Office Action Summary

10/797,255

ROARTY, BRIAN P.

DETAILED ACTION

Gray French; Figure 1, page 67

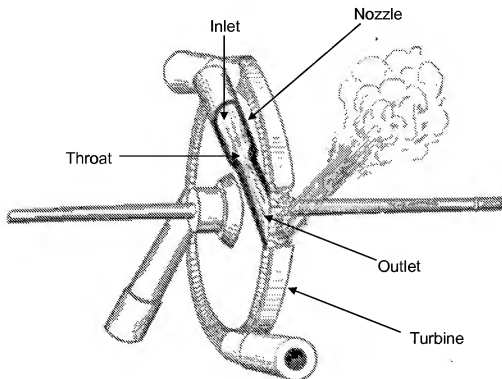
18. Regarding Claim 4, Gray French teaches a system comprising a nozzle having an inlet, a throat, and an exhaust (see figure below); a fluid flowing through the nozzle; and a means (i.e. turbine) for transforming the flow from the exhaust into work outside the system. Gray French fails to teach a means embedded within the nozzle for transferring energy into and heating the nozzle, thereby indirectly transferring energy into and heating the fluid and inducing a phase change in the fluid. Patterson teaches a means 38/44/36 embedded within a nozzle 12 for transferring energy into and heating the nozzle 12 (column 2, lines 15-17); thereby indirectly (through means 36) transferring energy into and heating the fluid and inducing a phase change in the fluid (column 3, lines 59-60).

19. Regarding Claim 5, Gray French teaches a system wherein the cross-sectional interior volume of the inlet, throat, and exhaust of the nozzle vary only across one plane perpendicular to the axis of the fluid flowing through the nozzle (see figure below).
